## FAIRFAX COUNTY HEALTH DEPARTMENT SEWAGE DISPOSAL SYSTEM/WELL WATER SUPPLY AS-BUILT

# FAIRFAX CONTY DIVISION OF ENVIRONMENT SEWAGE EFFLUENT PUMP CALCULATIONS

# FAIRFAX COUTY DIVISION OF ENVIRONMENT HEALTH SEWAGE EFFLUENT PUMP CALCULATIONS

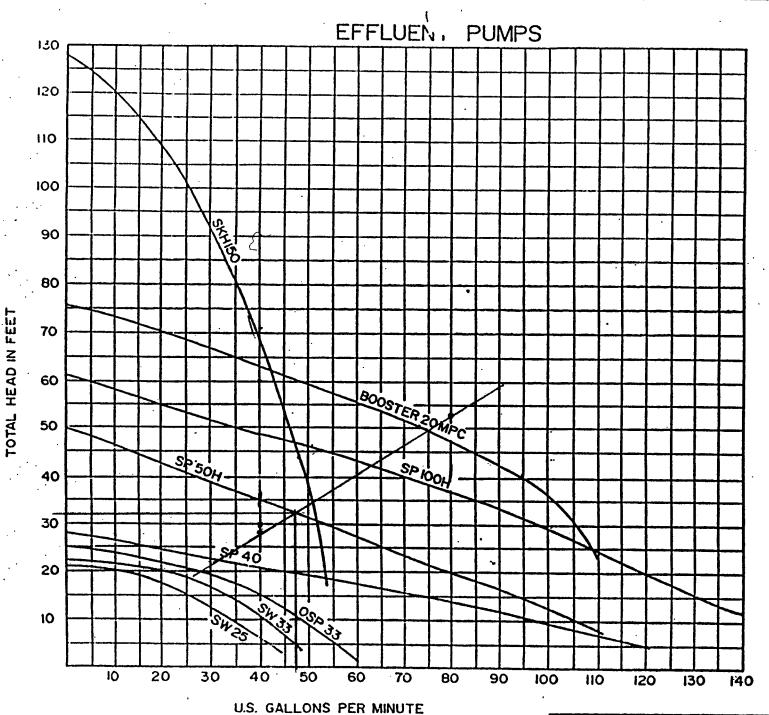
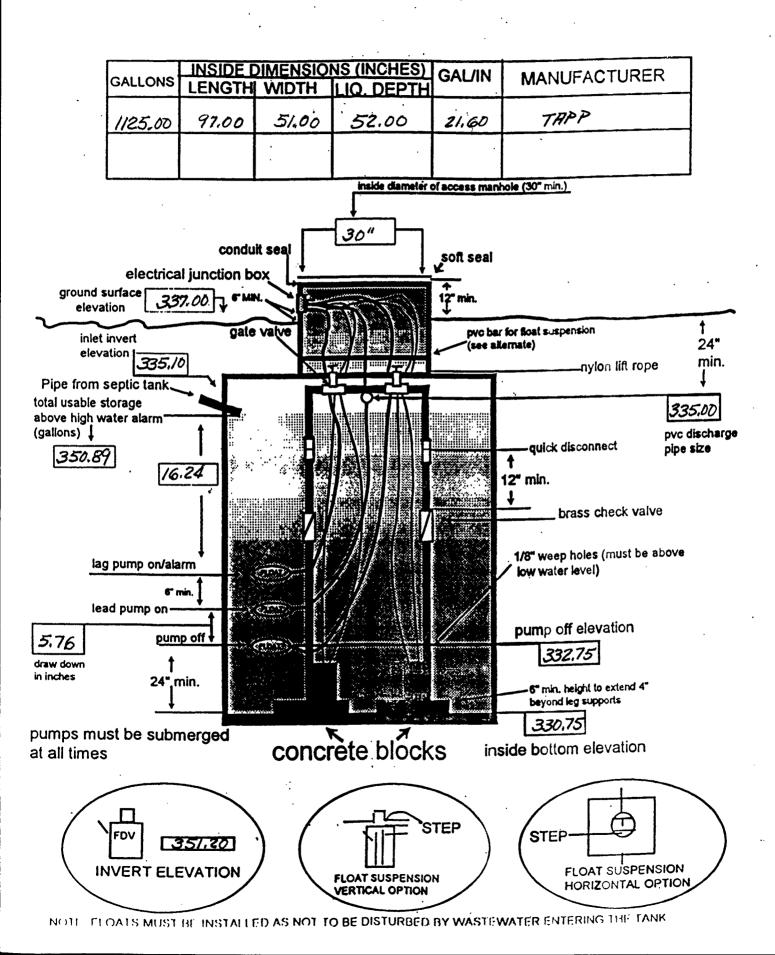
REJECTED FOR REASONS NOTED

MUST USE TOP-JOINT TANKS IN NEW location. ME-PRODUCTS (aka-TAPD CONST) DOES NOT YET HAVE TOP-TOINT TANKS APPROVED BY FCHD. Spec A TANK FROM OUR TABLE

(COPY ATTACHED)

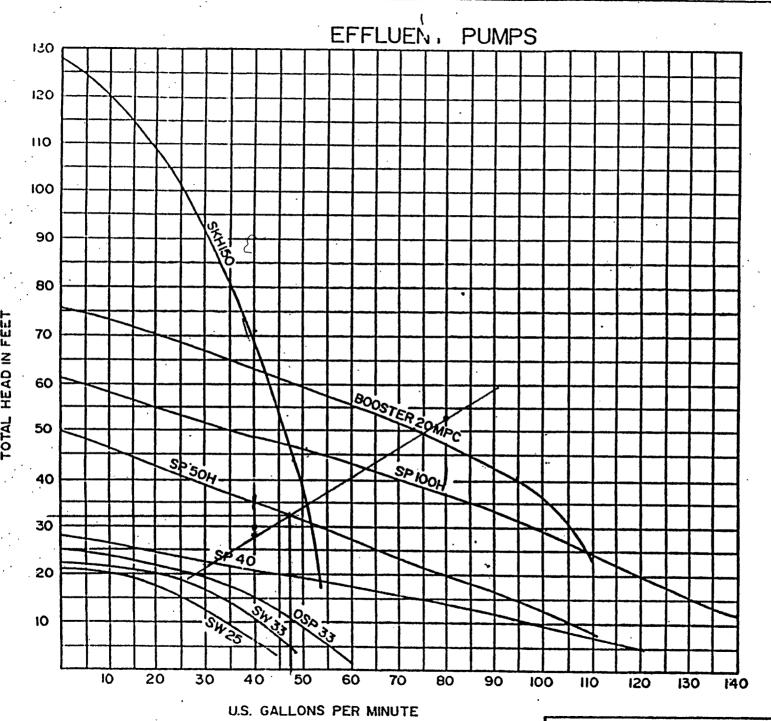
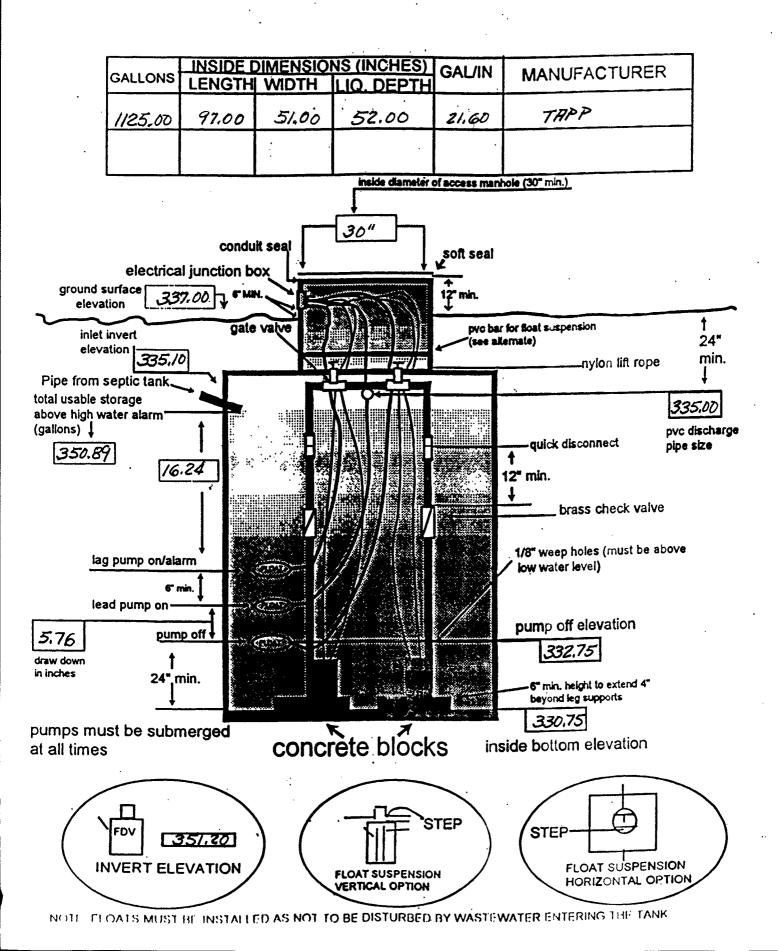
rejected for neasons noted

MUST USE TOP-JOINT
TANKS IN NEW LOCATION.

ME-PRODUCTS (aka-Tapp Const)

DOES NOT YEST HAVE TOP-JOINT
TANKS APPROVED BY FCHD.

EC A TANK FROM OUR TABLE
(COPY ATTACHED)
